Access Compliance Report

Public Rights-of-Way

(Curb Ramps)

| Intersection ID: 43687 | Main Street: PORTSTEWART_LN | Cross Street: TODDINGTON_LN | Location: SE |

| ADA ID: 39CF1D632BE6 | Ramp Type: PerpDiag | Initial Pass/Fail: Fail | Overall Compliance: No |

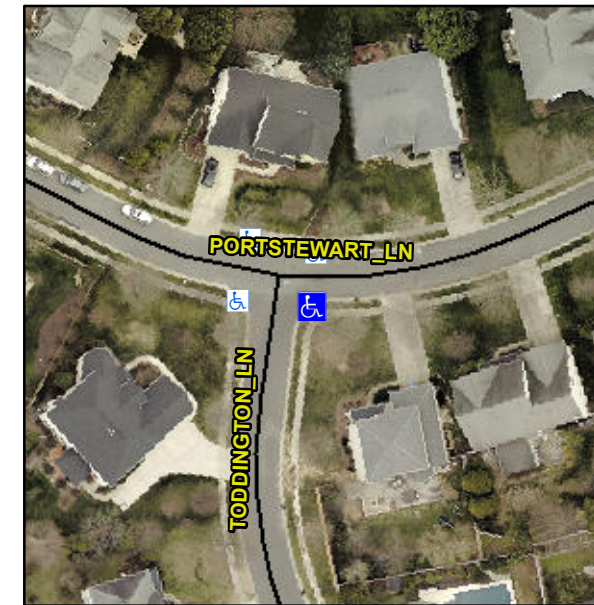
Not Found, R304.5.1, R304.5.3

| Compliance | Description | Data | Compliance | Description | Data |
|------------|-----------------------|------|------------|-----------------------------|------|
| No | Ramp Width (in) | 39.0 | No | Ramp XSlope (%) | 3.4 |

Remove & Replace Curb Ramp With Two New Directional Ramps or Equivalent.
